PCN	Product Change Notification	De-21-05-0465	
Product	ERmet ZD / ERmet ZDpro	Date of Publication:	
		10.05.2021

Title: Modification of the female housing

Type of Notification: major (A) change

old geometry

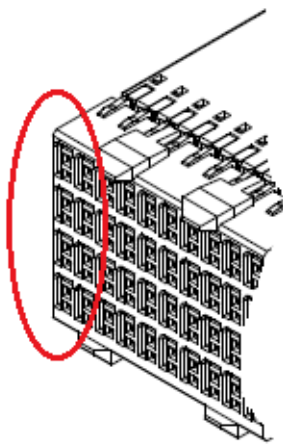
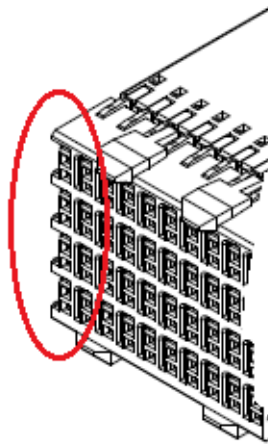
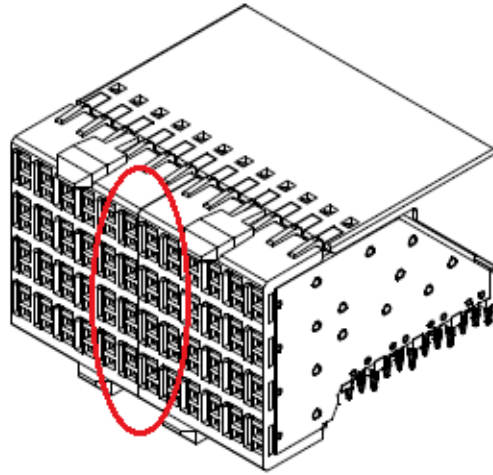
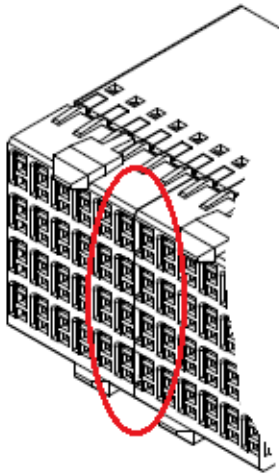
To optimize the manufacturing and handling process of the female ERmet ZD and ERmet ZDpro connectors the geometry of the connector housings has changed. The bars at the mating face have been removed. This change has no influence on the mating behavior.

Parts with the old geometry will be shipped until the existing inventory is exhausted. These change will be operated without partnumber change.
